# Staff Report

**To:** Salt Lake City Administrative Hearing Officer  
**From:** Krissy Gilmore, Senior Planner  
Kristina.Gilmore@slcgov.com, 801-535-7780  
**Date:** May 23, 2024  
**Re:** PLNSUB2024-00289, Cannon Point Phase 1 Subdivision Amendment

## Preliminary Plat

# PRELIMINARY PLAT OF CANNON POINT PHASE 1 AMENDED VACATING AND CONSOLIDATING LOTS 7, 8 AND 10 OF CANNON POINT PHASE I SUBDIVISION

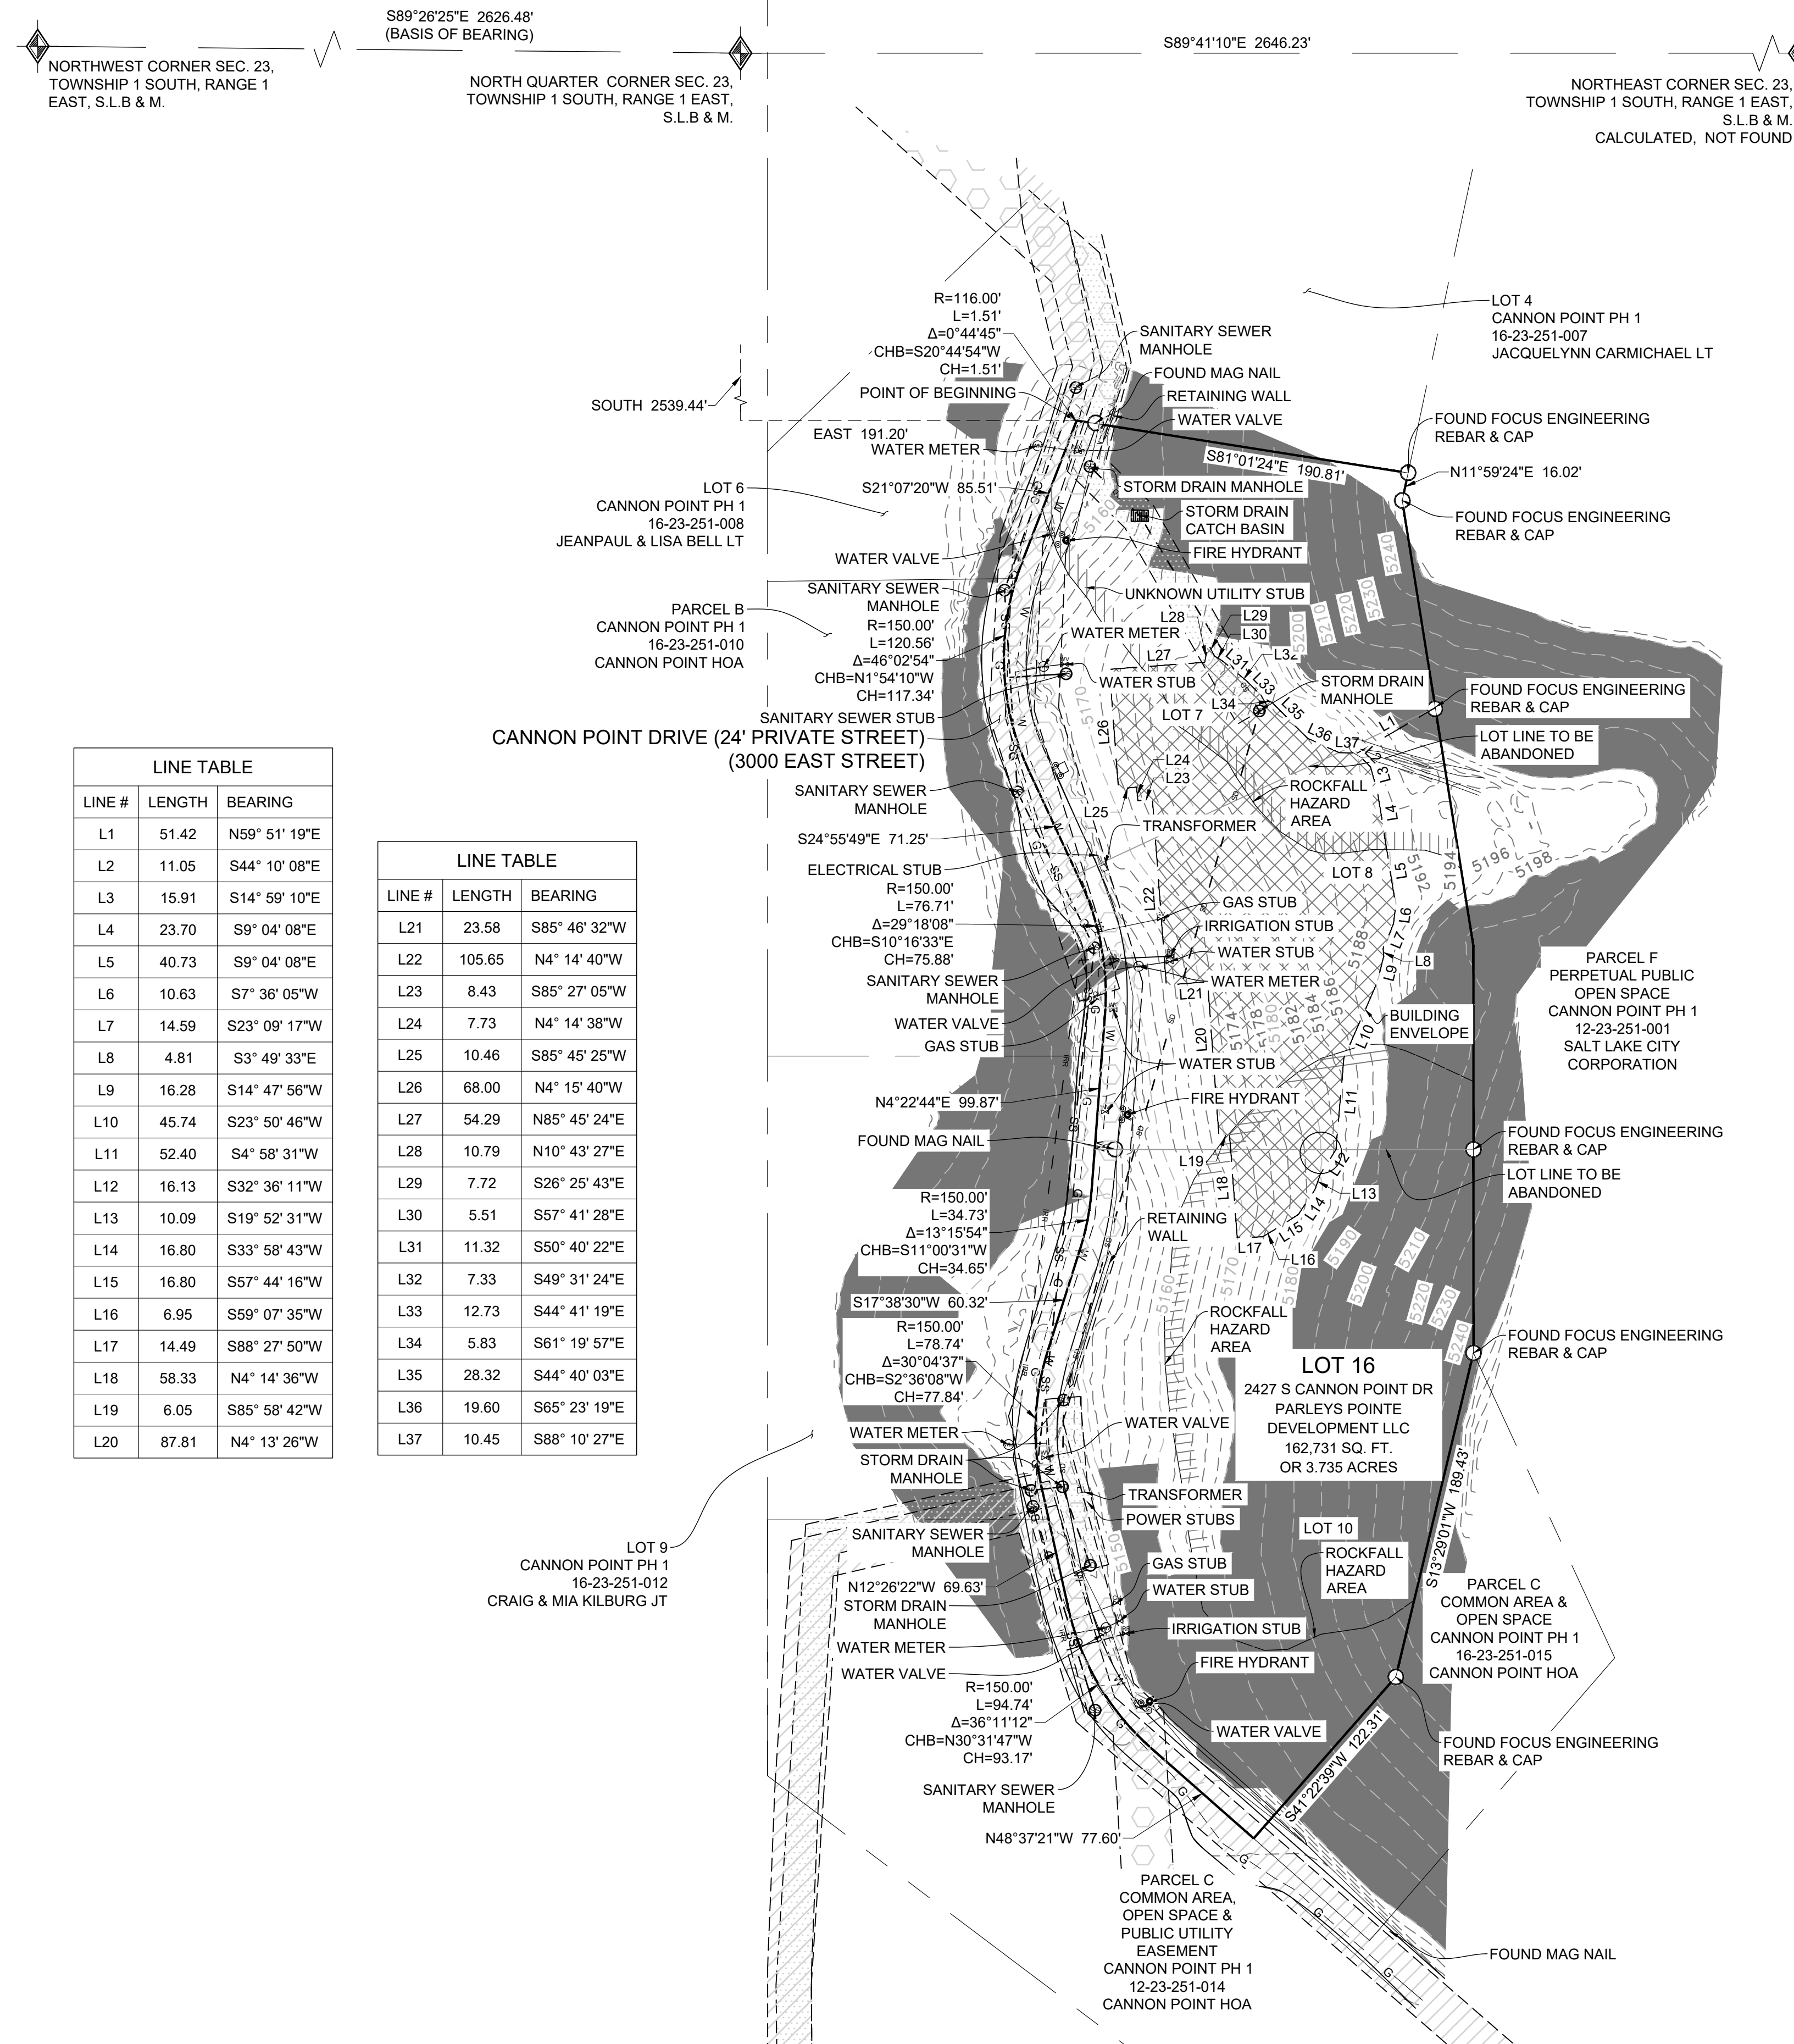
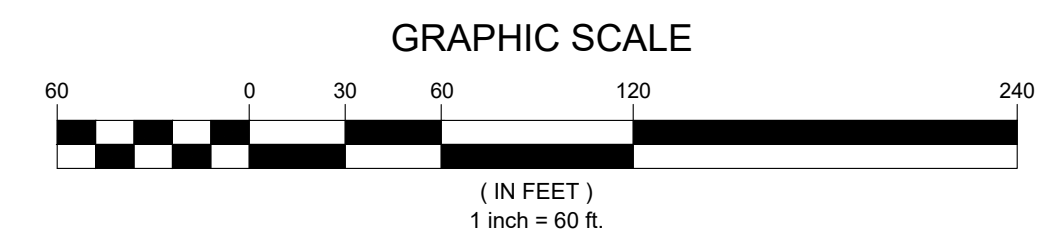
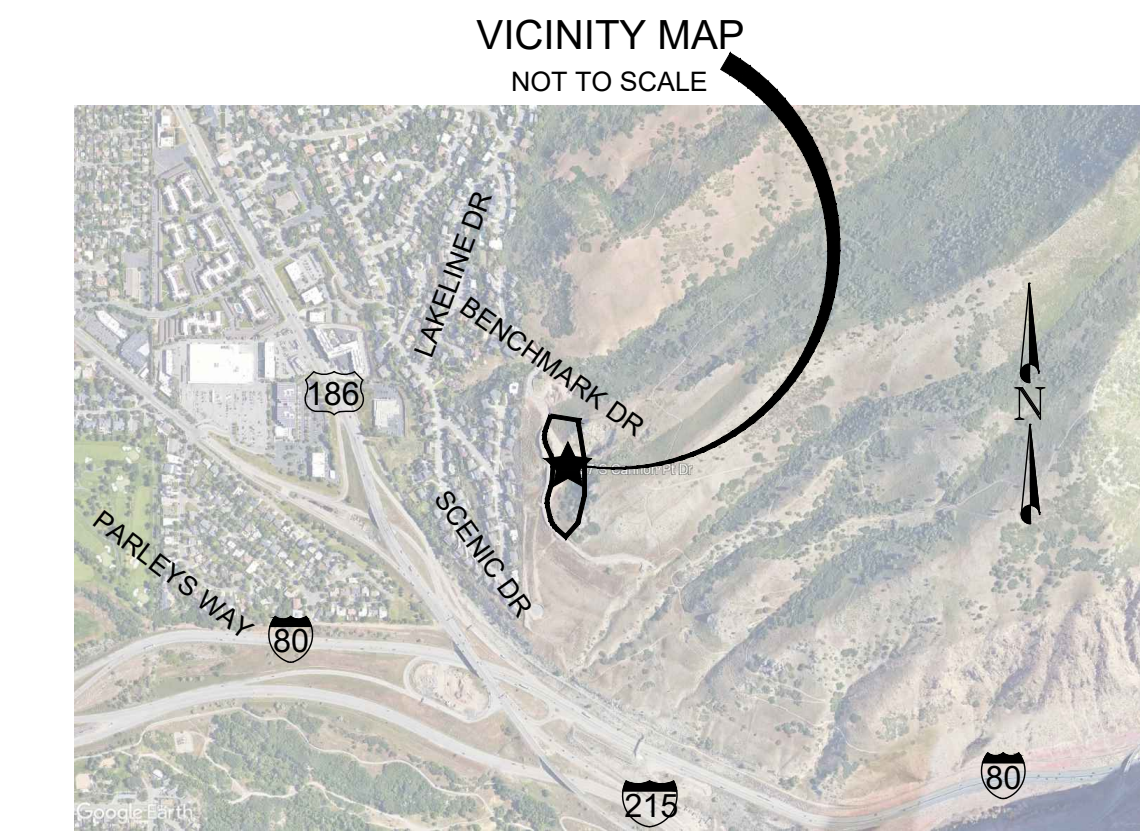
Public Utilities reviewed the plat and provided the following comment: *As Public Utilities can only allow one culinary water meter and one irrigation water meter per lot, the existing stubbed water services will need consolidated to a single culinary water meter/service and a single irrigation water meter/service. Fire services are allowed, as necessary. Each lot currently has a culinary water service and fire service stubbed to the property, totaling 6 stubbed water services. This will require that several existing stubbed services are killed at the public water main per SLCDPU standards.*

Addressing: I've attached a minor labeling redline to the Cannon Point Phase 1 Amendment subdivision plat. The certified address should be based off the location of the front entrance of the home to be built on that consolidated property, but for the purposes of this lot consolidation drawing the address they have for the new Lot 16 will suffice. They should be required to obtain a new address certificate. I've included a blank application for a certified address Krissy Gilmore can forward to her applicant if she's willing.

*Planning note: Redlines were addressed by the applicant and are reflected in the proposed preliminary plat.*
